Wednesday, August 7, 2013 City Council Chambers

**7:10 PM COMMUNITY CONFERENCE: Issaquah Middle School,
Application PLN COM13-00002**

CITY OF ISSAQUAH
Development Commission - Minutes

PUBLIC HEARING: Issaquah Plaza 221

Exhibit 8
sheet 6 of 6

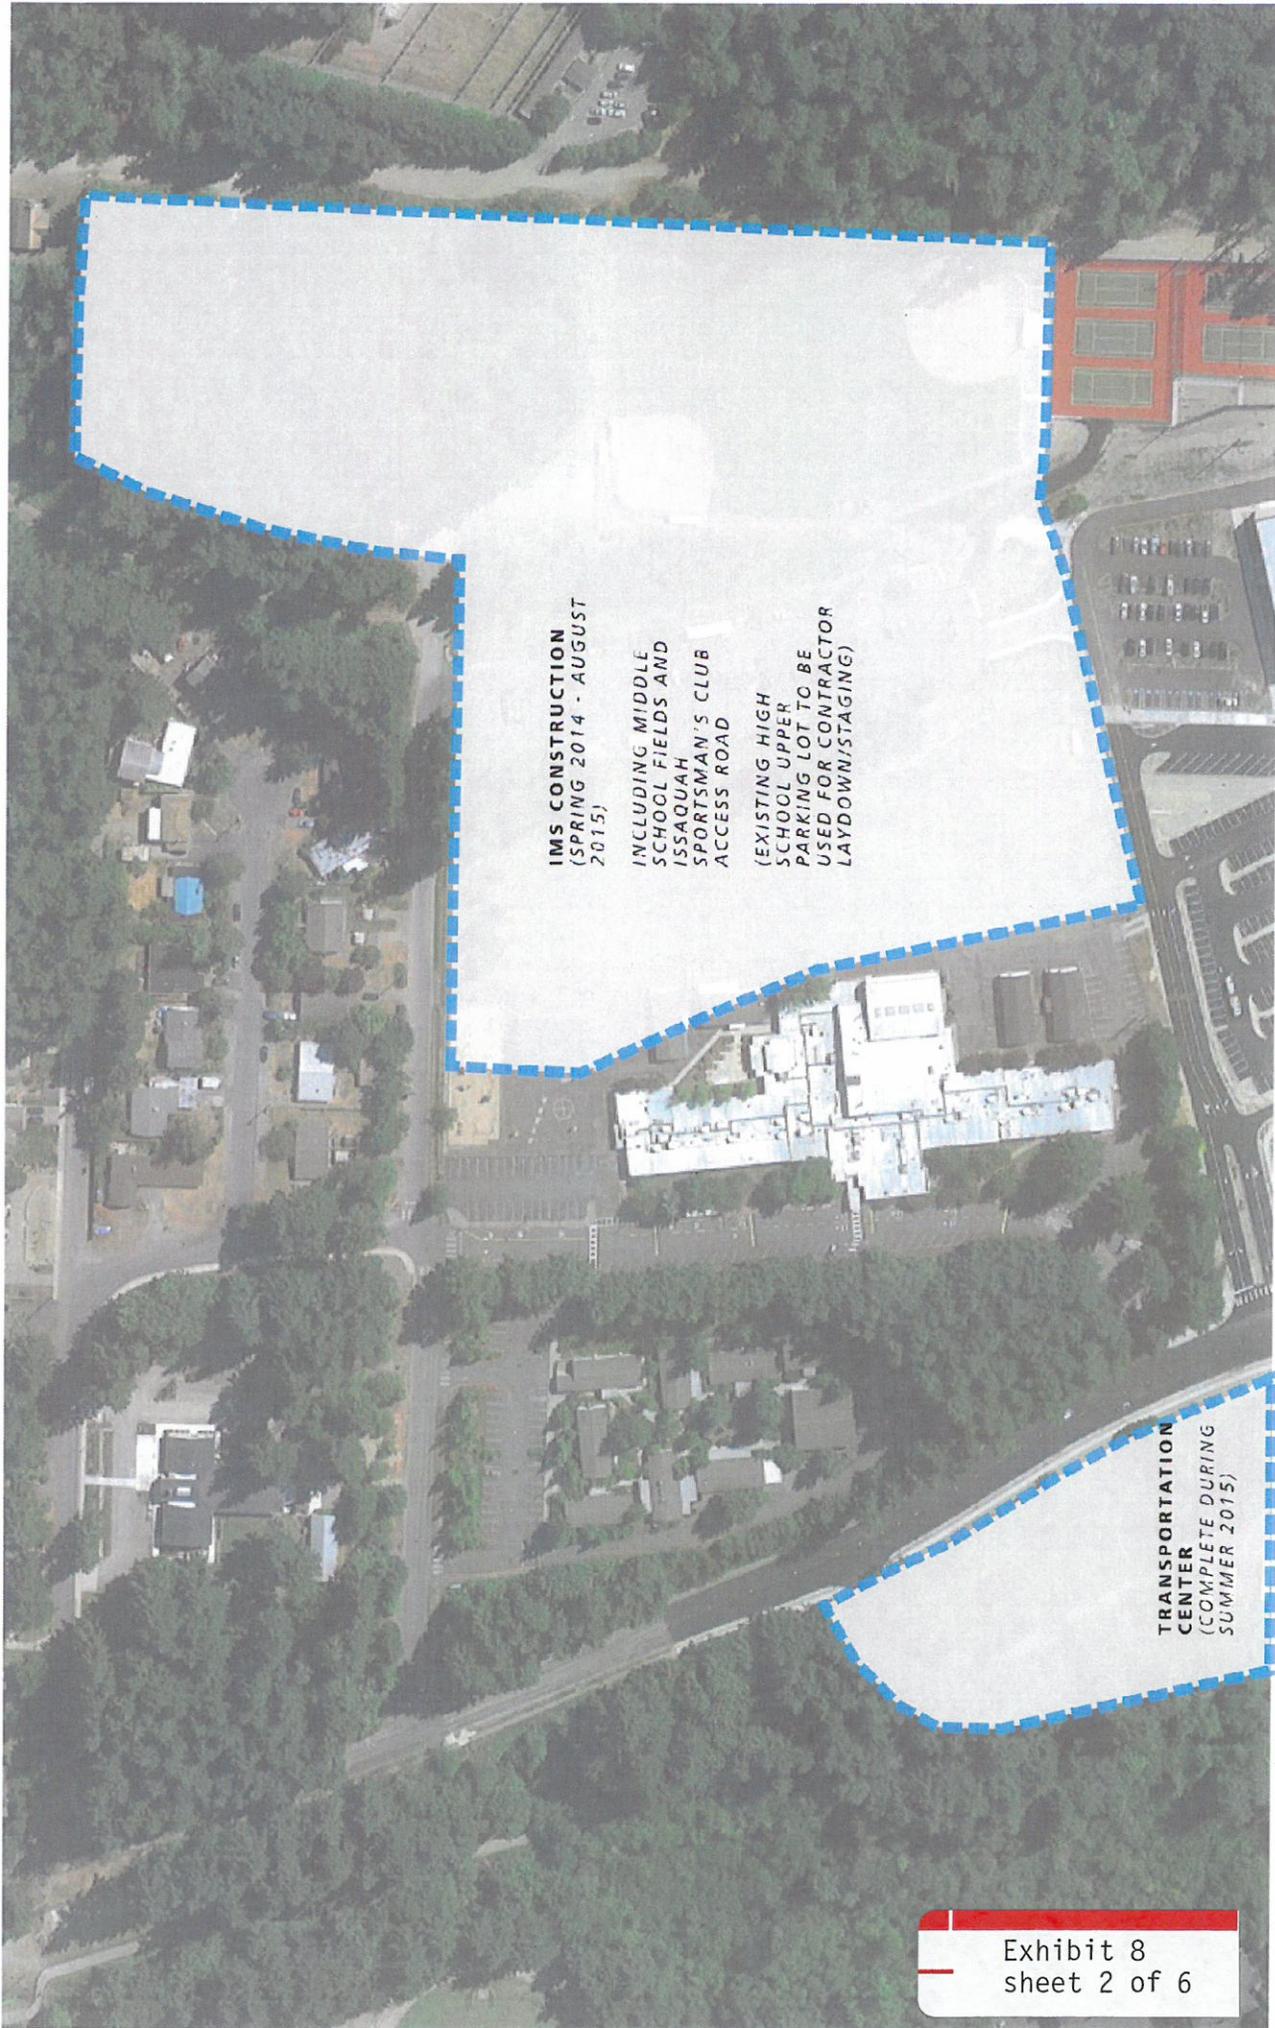
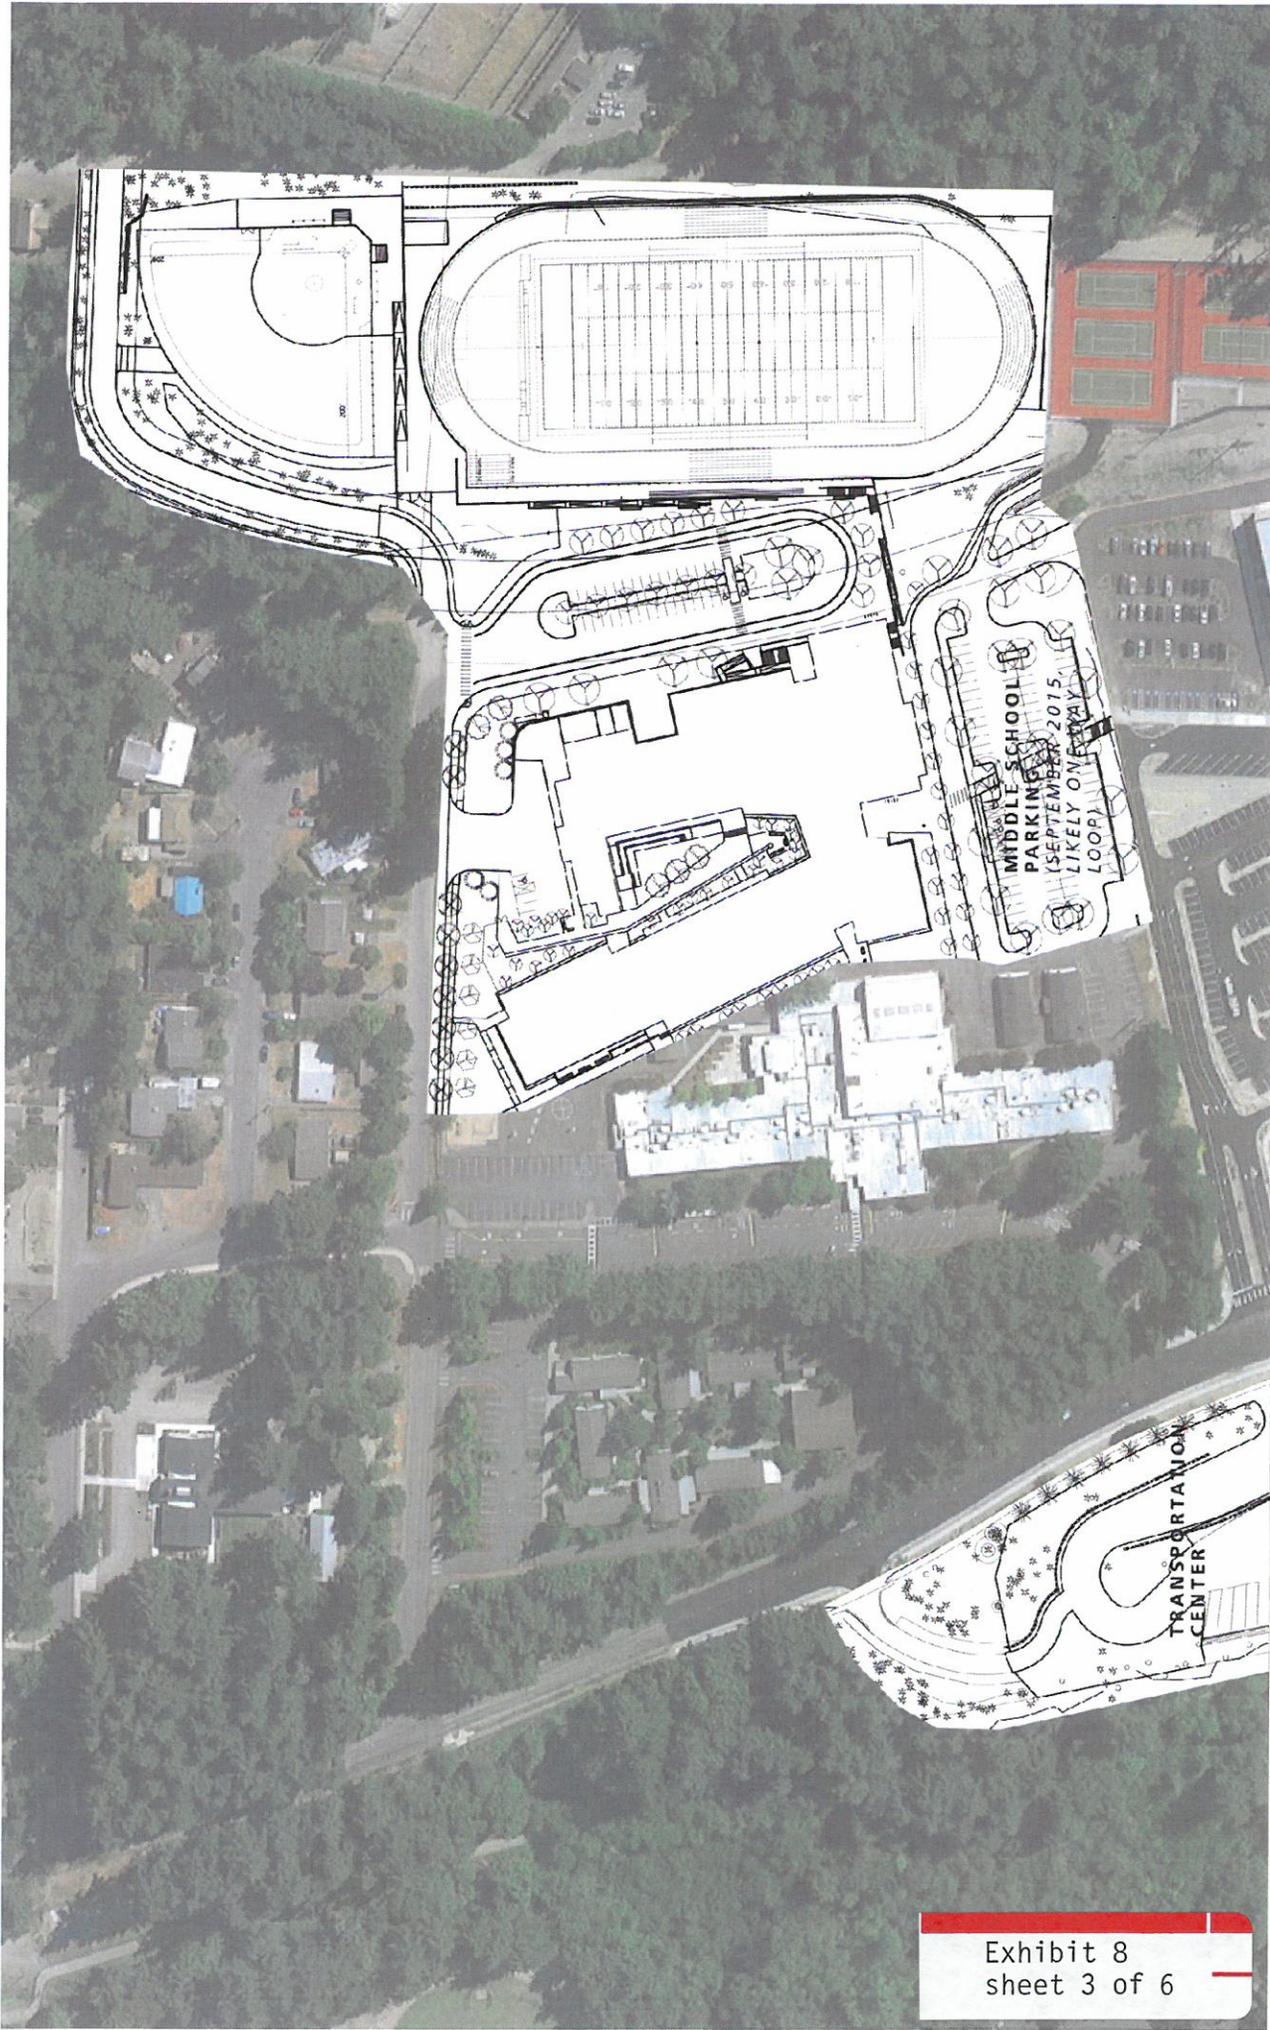
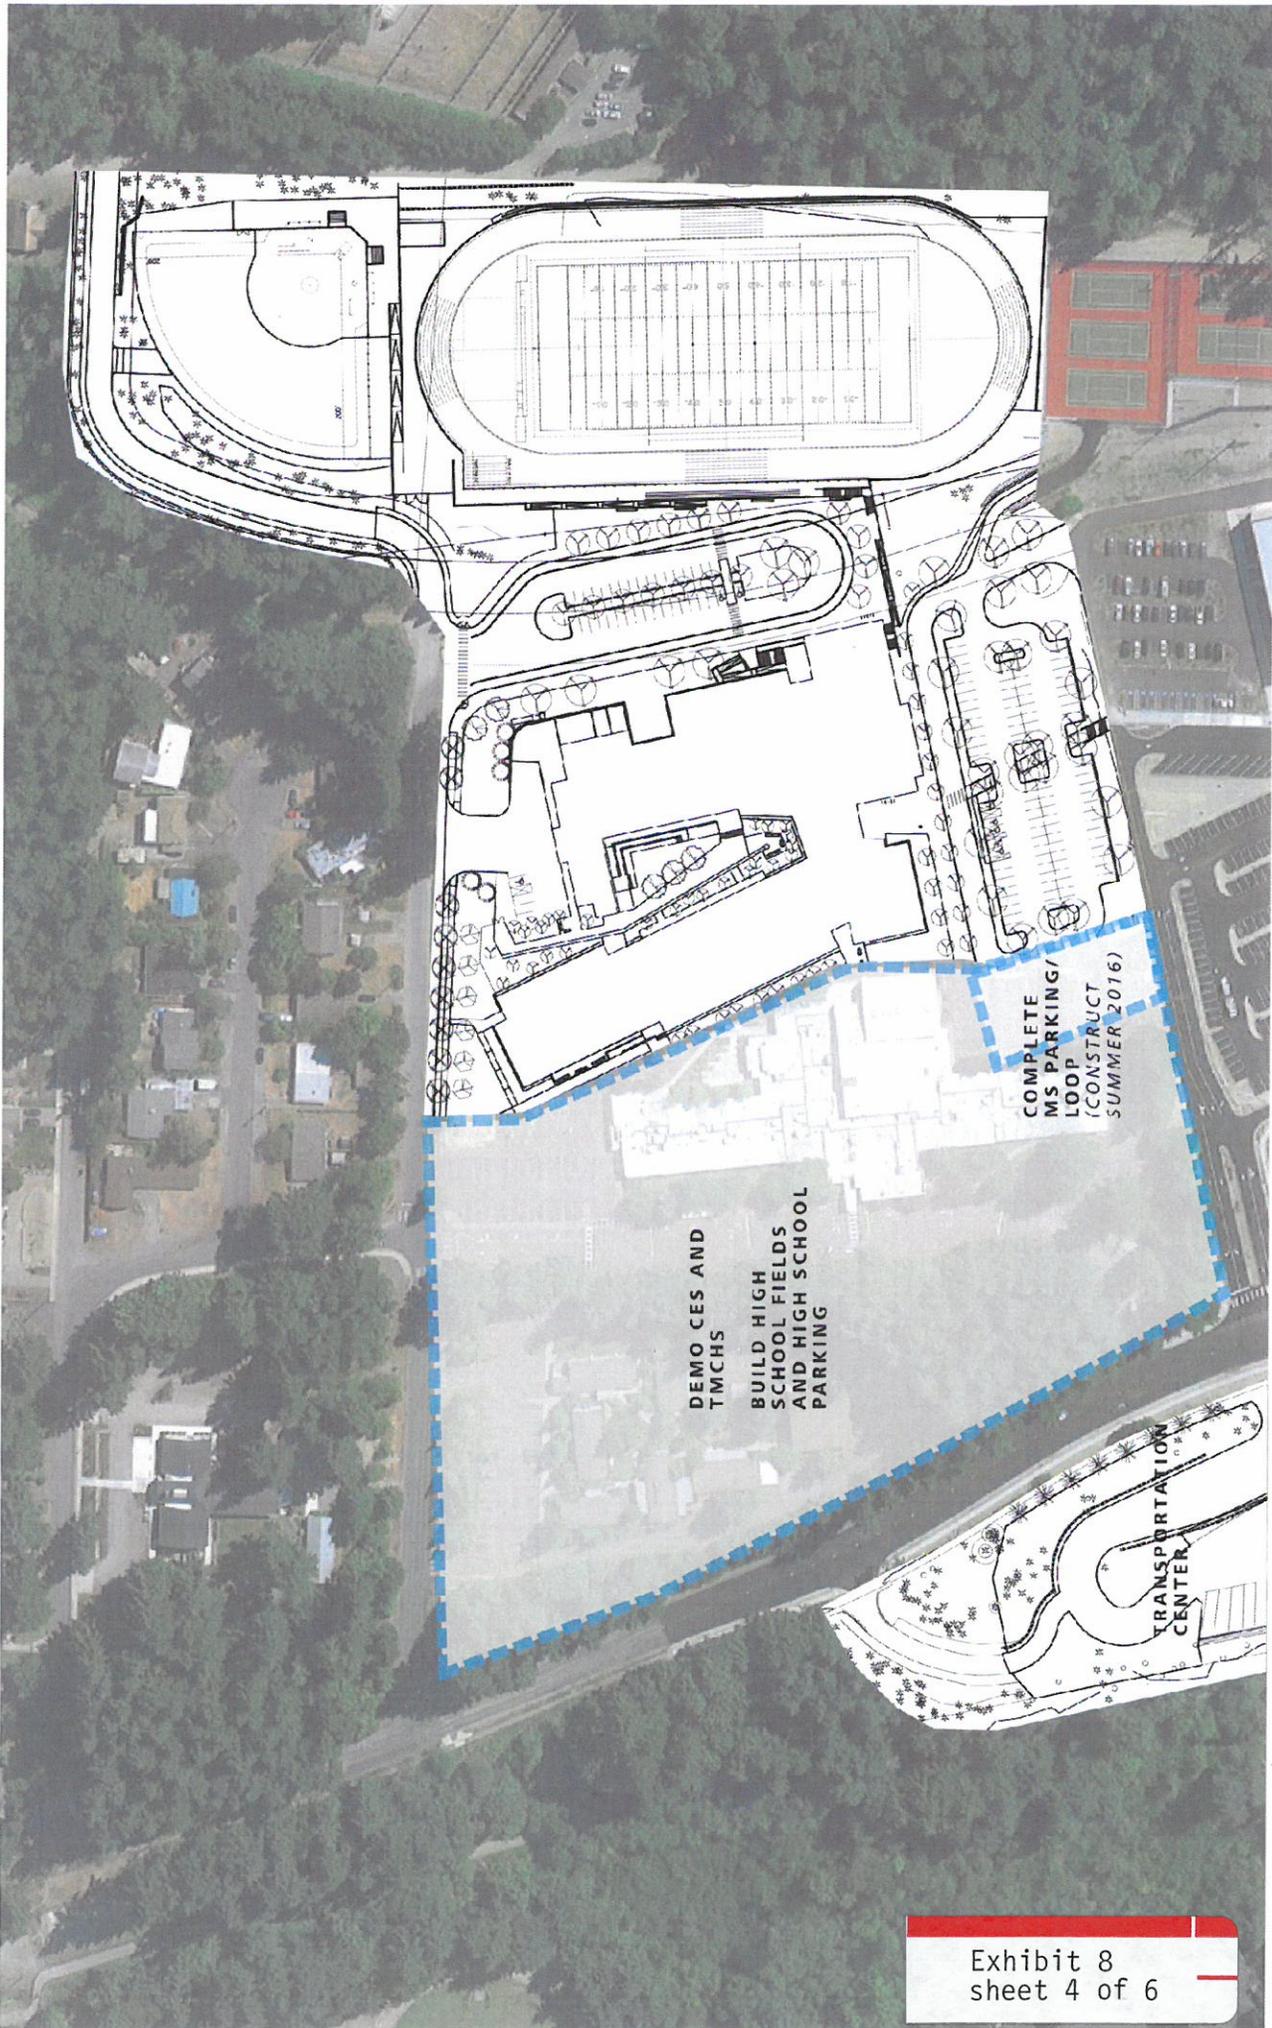
Aerial photos with the project development imposed on those aerials illustrate the phasing of the Middle School project (6 sheets show phasing with Exhibit 8). The entire project will take a few years to complete with different areas of the large site being affected at different times with regards to demolition, staging and construction. The narrative states that the school project will occur in 3 phases as follows:

With submittal of the Master Site Plan application, the School District will need to submit a detailed plan for the phasing and staging of the entire project. Of special interest will be how the school proposes to address parking for the adjacent high school students
